Arboricultural Technical Note:

**Response to comments made by the Landscape
and Trees Officer on planning application ref:
232298**

February 2024

Ref. SJA ten 23644-01b

Figure 1 – Indicative section

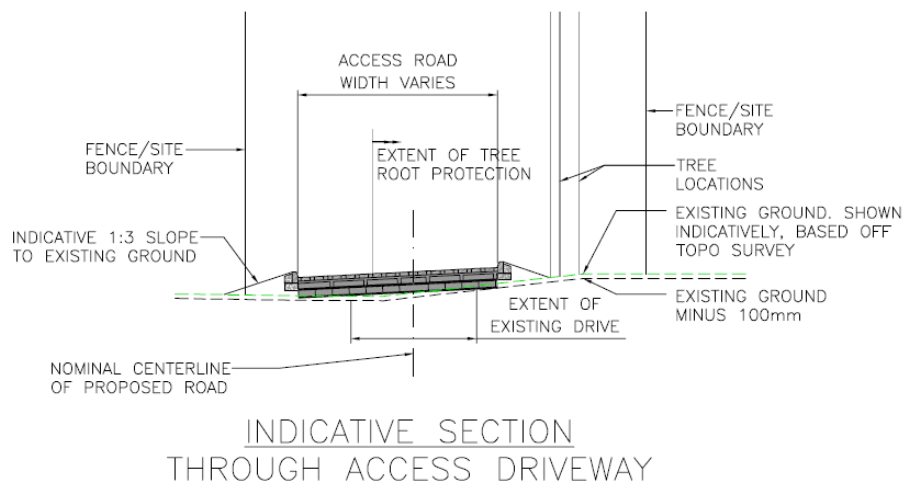
2.4. The principles for securing access using an above soil surface were established in the outline approval and additional information should not be needed at this stage. However, cross sectional drawings have been provided by WSP to help illustrate that the new surface can indeed be constructed above the existing and the levels strategy discussed below demonstrates that the levels also accommodate this build up.

2.5. The above soil construction will comprise a 150mm thick layer of Cellweb, a bitumen layer and a finishing layer of sand and block paviours. The bitumen layer is

needed because of the likely use of the drive and the need to accommodate construction. It will act as a sacrificial wearing course through the development and once the building work is complete it will be drilled at 750mm centres to ensure its long-term porosity. The final finish to the drive will be permeable block pavements. This is illustrated in the cross-section below at Figure 1.

2.6. The cross-section shows the ‘worst-case’ scenario where the drive is at its narrowest. It also shows a 100mm scrape of the topsoil. This is desirable but not essential. Its installation will be subject to arboricultural supervision to be included in the arboricultural method statement. If shallow or surface roots are encountered then these will be retained and there is scope to install the new surface without the 100mm scrape.

APPENDIX 1
Revised Tree Protection Plan

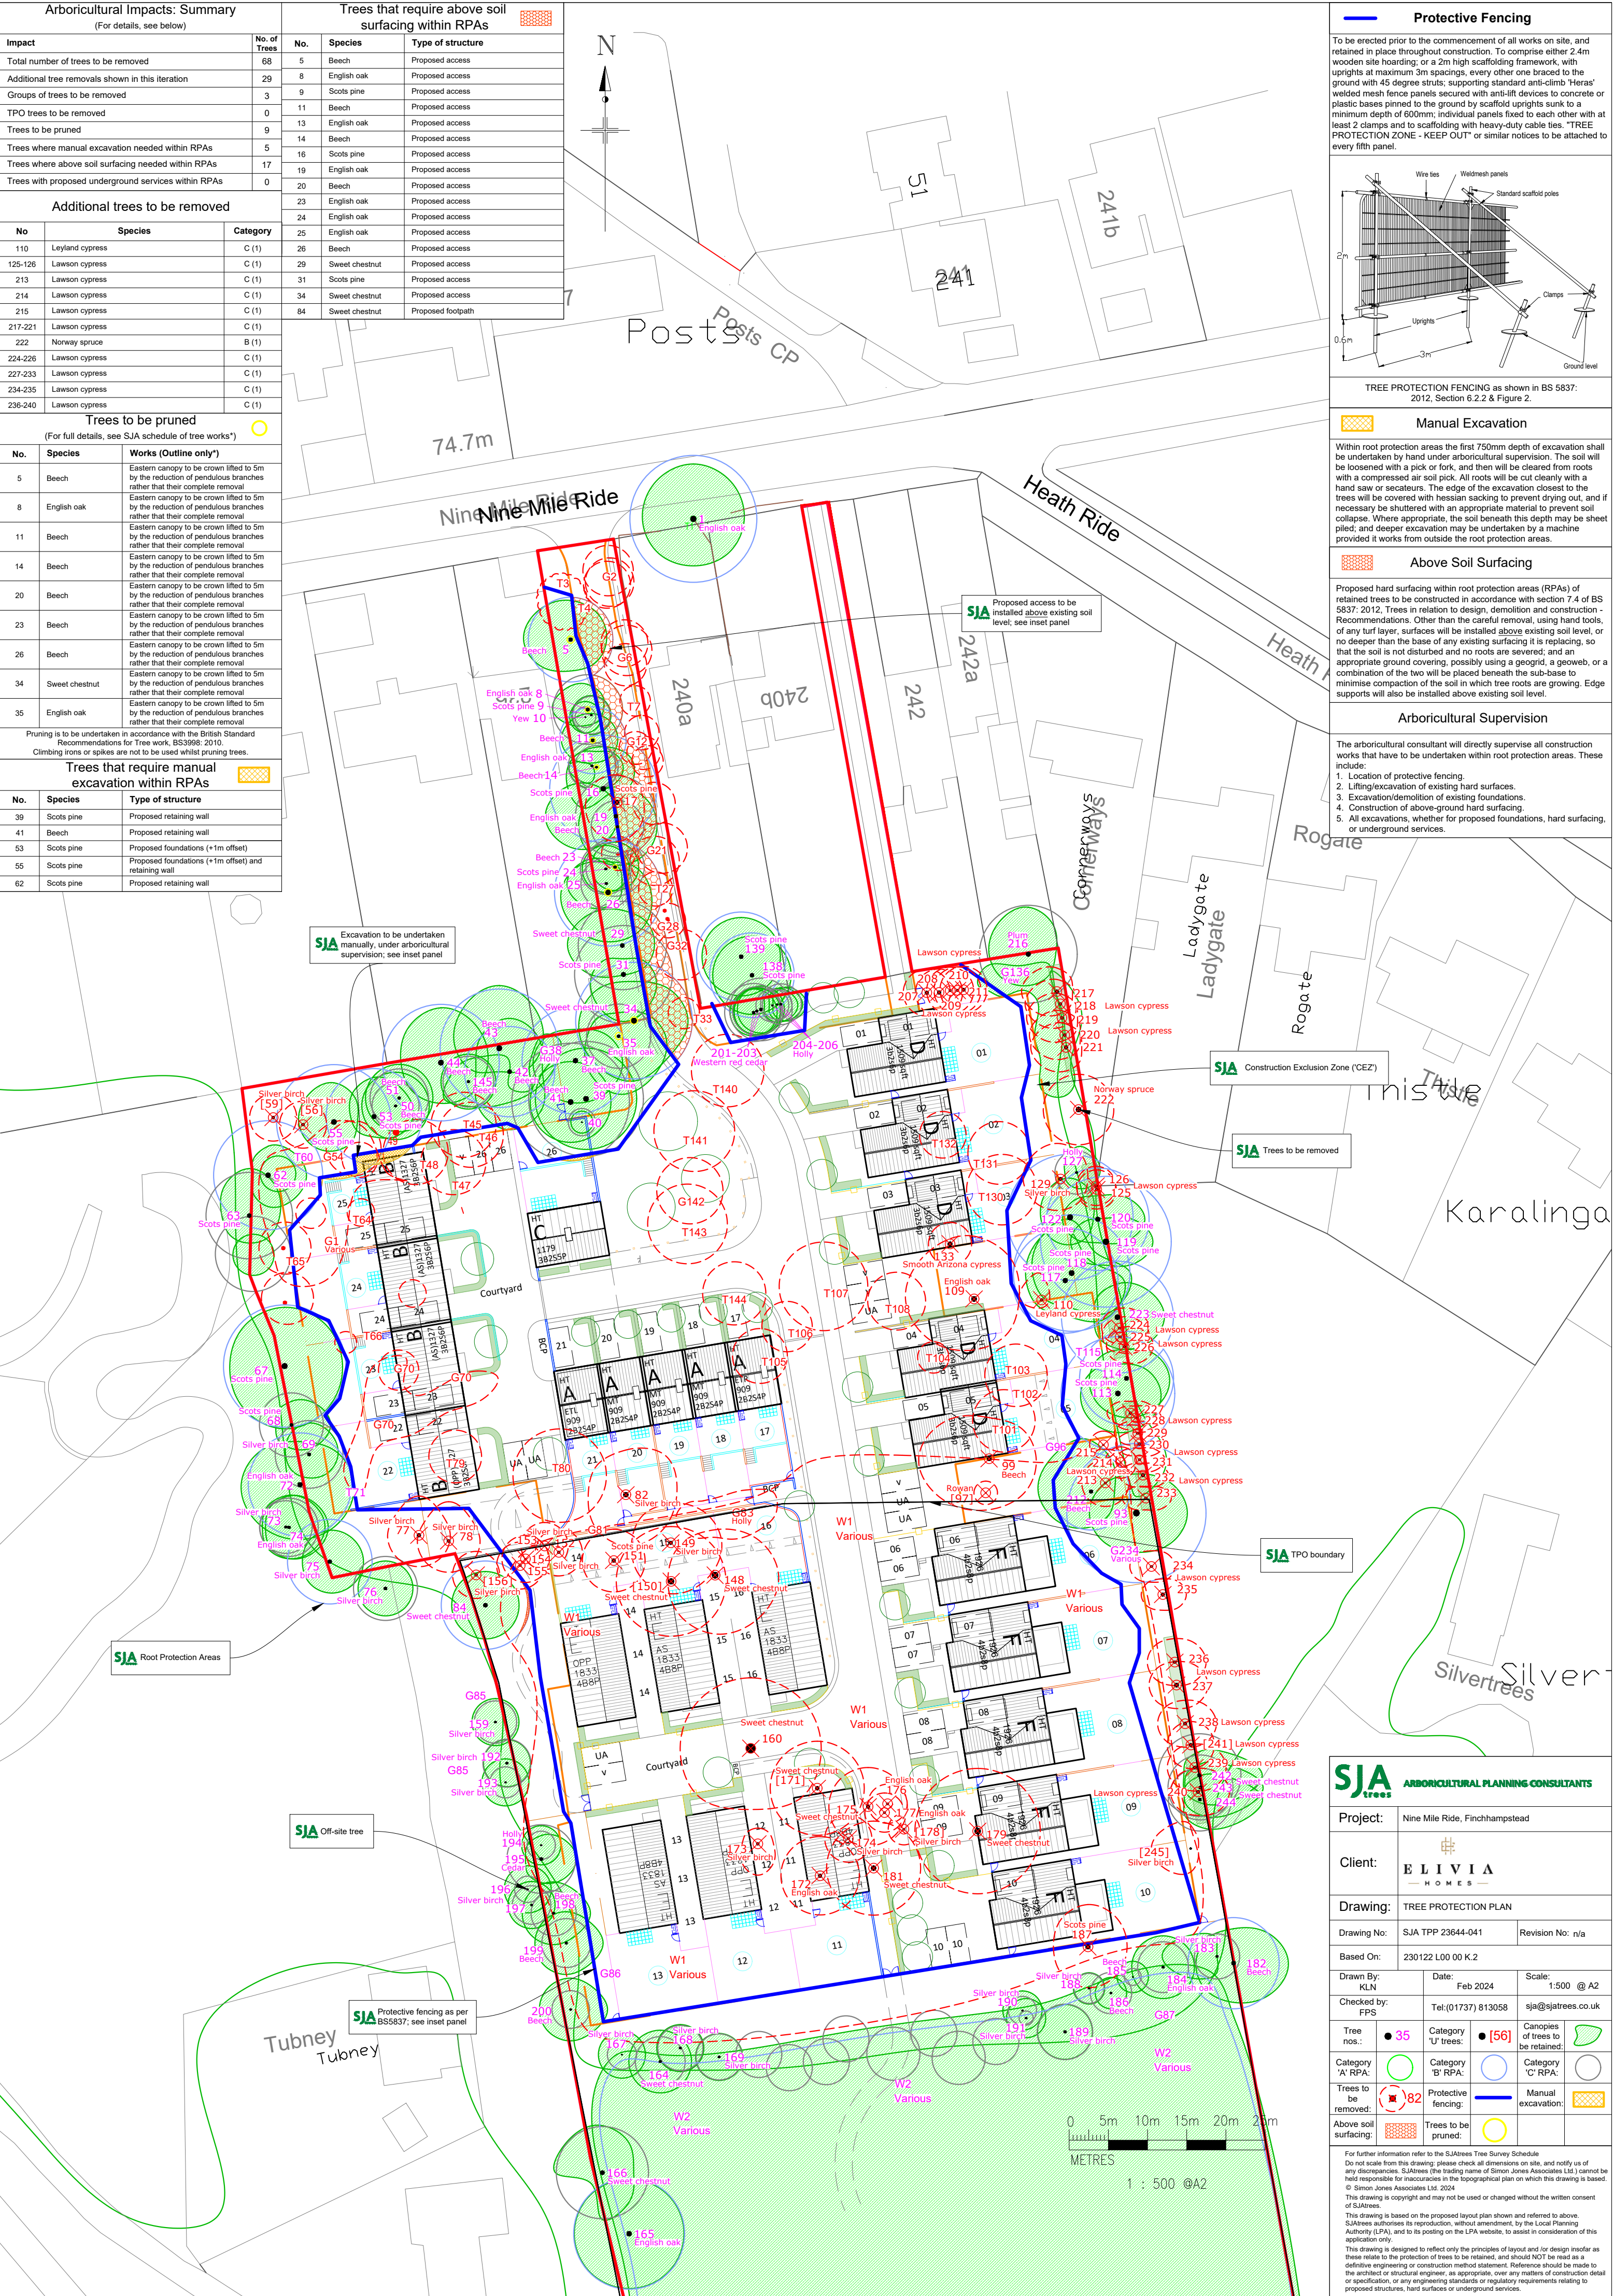
1.5. Whilst not a feature of our report submitted with the application it was discussed at the application progress meeting on the 18th December 2023, that the Officer was amenable to the idea of removing the Lawson cypress trees on the eastern boundary of the site and replacing them with a native hedgerow with native hedgerow. Indeed, this view was expressed in her comments.

3.1. The Officer is quite right to highlight this. The existing drive is a vehicular access and the trees already have a reasonable clearance over the driveway and this does not prohibit its use at present. However, the lowest canopies of trees overhanging the driveway have between 3 and 5m clearances. It would be appropriate to lift the canopies over the retained trees over the driveway to provide 5m clearances.

1.6. Therefore, these trees are now shown for removal. Along with the submission of a new (slightly amended layout) this change is significant enough to warrant an

update to our tree protection plan (TPP). The TPP submitted with the application should therefore be superseded by the new TPP presented at **Appendix 1** of this note.

3.3. The pruning that is required to implement the proposals has been included in the updated tree protection plan at **Appendix 1** of this note.

4.1. Significant work has been carried out by the design team to secure a levels strategy for the site. As would be the case if the levels strategy were produced post-permission, the trees to be retained have been treated as significant constraints and their root protection areas (RPAs) respected. The strategy has secured a design that does not result in any level changes within the RPAs of retained trees. However, this has resulted in some very minor adjustments to the layout, and these are reflected in the updated TPP presented at **Appendix 1**.
